SI B11 05 16
Engine

Service Action: S63 Engine – Replace Crankcase Vent Connecting Line

E70 (X5 M)

E71 (X6 M)

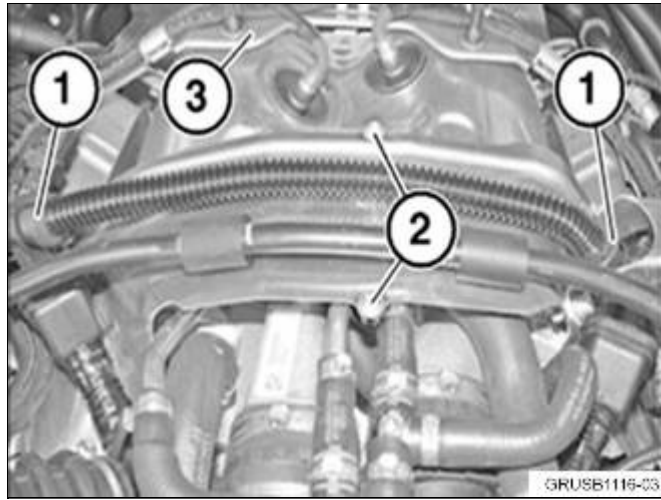
The crankcase ventilation connection line may deteriorate prematurely causing any of the following:

- vacuum leak
- various fault codes related to mixture control stored in the DME
- customer complaints about rough idle speed
- Check Engine Light illumination.

Replace crankcase ventilation connection line.

<ol style="list-style-type: none"> 2. Replace the connecting line
--	--

between crankcase ventilation hose of bank 1 and bank 2 (release the quick connections at positions 1).
